dsPIC33EVXXXGM00X/10X FAMILY

dsPIC33EVXXXGM00X/10X Family Silicon Errata and Data Sheet Clarification

The dsPIC33EVXXXGM00X/10X family devices that you have received conform functionally to the current Device Data Sheet (DS70005144H), except for the anomalies described in this document.

FIGURE 1:

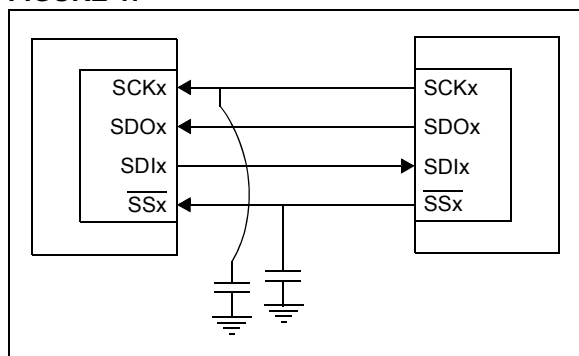
When the SPIx module is configured in SPIx Slave mode (MSTEN bit (SPIxCON1[5]) = 0), the frame slave (FRMEN bit (SPIxCON2[15]) = 1) and the SPIFSD bit (SPIxCON2[14] = 1), in Standard Buffer mode with the Clock Polarity Select bit, CKP = 0, the data are not transmitted in both 8-bit and 16-bit mode, but the data are being received correctly.

Adding a capacitance on the signal, as shown in Figure 1, will help the data to be received properly.

FIGURE 3: ILLUSTRATION OF 1 TOSC GLITCH WHEN PWM OVERRIDE IS TURNED OFF

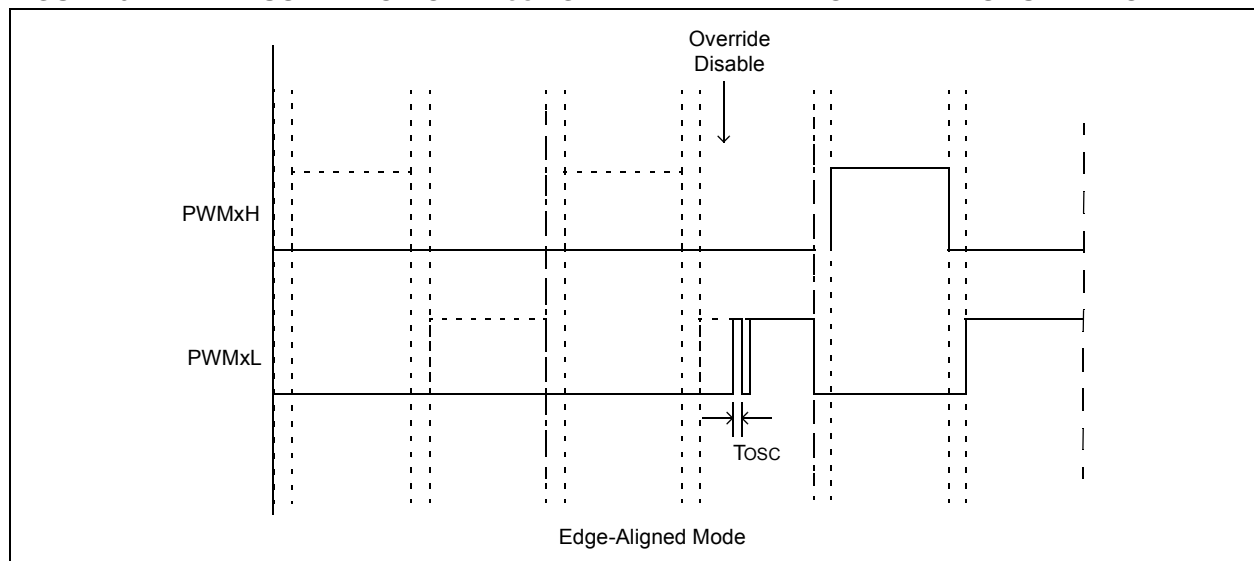
In Complementary mode after the PWM module is enabled ($PTEN = 1$), if the PWM override is turned off, a one TOSC glitch will be present on the rising edge of either the PWMxH or PWMxL pins, whichever occurs first, as shown in Figure 3.

The glitch will be present on PWMxH/PWMxL every time the override state is changed from override enabled to override disabled. The width of this glitch is equal to one TOSC when $PCLKDIV[2:0]$ ($PTCON2[2:0]$) = 000. Increasing the PWMx input clock prescaler setting will increase the width of the glitch accordingly.

FIGURE 4:

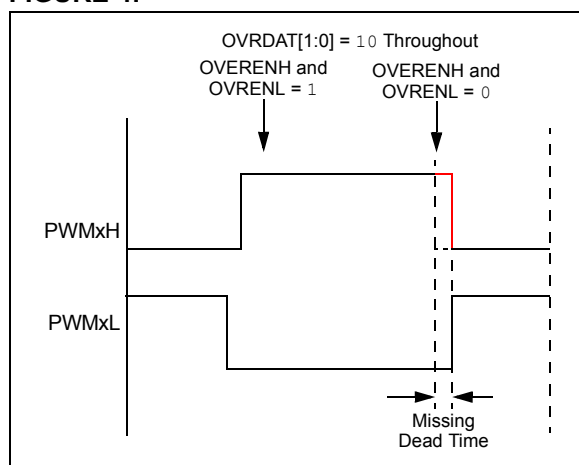
In Complementary Output mode, the expected dead time between transitions of the PWMxH and PWMxL outputs may not be asserted when the following occurs:

- Output override synchronization is configured to occur on the CPU clock boundary (IOCONx[0] = 0);
- Both PWMxH and PWMxL overrides are enabled prior to the event (OVRENH and OVRENL are both '1'), and
- Both overrides are disabled (OVRENH and OVRENL are both '0') at the instant the dead time should be asserted (Figure 4). This has been observed in both Center-Aligned and Edge-Aligned modes.

FIGURE 5:

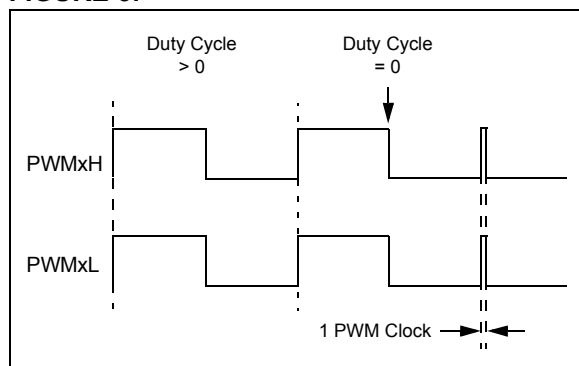
In the Redundant Output mode (IOCONx[11:10] = 10) and Push-Pull Output mode (IOCONx[11:10] = 01) with Immediate Update disabled (PWMCONx[0] = 0), when the Duty Cycle register is updated from a non-zero value to zero, a glitch pulse of a width equal to one PWM clock will appear at the next PWM period boundary, as shown in Figure 5, for the Redundant Output mode. Here, the Duty Cycle register refers to the PDCx register if PWMCONx[8] = 0 or the MDC register if PWMCONx[8] = 1.

If the application requires a zero duty cycle output, there are two possible work around methods:

1. Use the PWM override feature to override the PWM output to a low state instead of writing to the Duty Cycle register. In order to switch back to a non-zero duty cycle output, turn off the PWM override. The override-on and override-off events must be timed close to the PWM period boundary if the IOCONx register has been configured with IOCON[0] = 0 (i.e., output overrides via the OVDDAT[1:0] bits occur on the next CPU clock boundary).

2. Enable the Immediate Update (PWMCONx[0] = 1) while configuring the PWM module, i.e., before enabling the PWM module (PTCON[15] = 1). With Immediate Update enabled, writes to the Duty Cycle register can have an immediate effect on the PWM output. Hence, duty cycle write operations must be timed close to the PWM period boundary in order to avoid distortions in the PWM output.

FIGURE 7: SIMPLIFIED BEHAVIOR

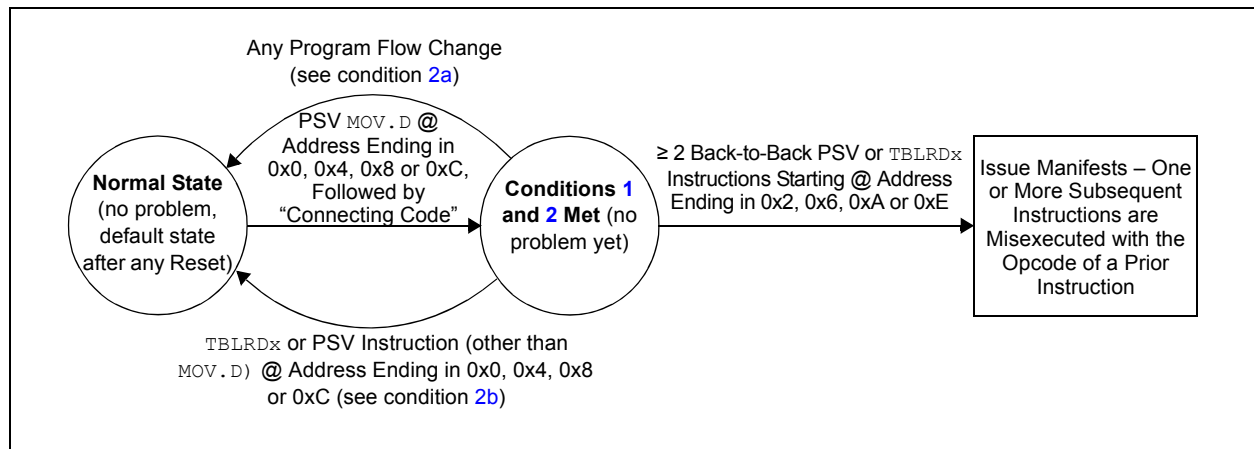
3.	≥ 2 back-to-back PSV or <code>TBLRDx</code> instructions are executed (following the code of condition 2), where the first of the back-to-back instructions is located at an address ending in 0x2, 0x6, 0xA or 0xE.

[Figure 7](#) provides an example of the effective behavior.

1. All instances of PSV `MOV.D` can be replaced with two PSV `MOV` instructions instead. Non-PSV `MOV.D` instructions acting on RAM/SFRs do not need to be modified; or
2. If not already present, a program flow change instruction (such as `BRA $+2`) can be inserted above back-to-back data Flash read sequences; or
3. Back-to-back data Flash read instruction sequences can be broken up by inserting a non-Flash read instruction (such as a `NOP`), in between the Flash read instructions; or
4. The alignment of the code can be shifted to avoid the required opcode location addresses.

C code built with MPLAB® XC16 Compiler Version 1.32, or later, implements the work around by default. However, if the application uses Assembly language routines, these should be manually modified to implement the work around. Additionally, if precompiled libraries are used, these should be built with XC16 Version 1.32 or later. For additional information, please visit: www.microchip.com/erratum_psrds_psrds
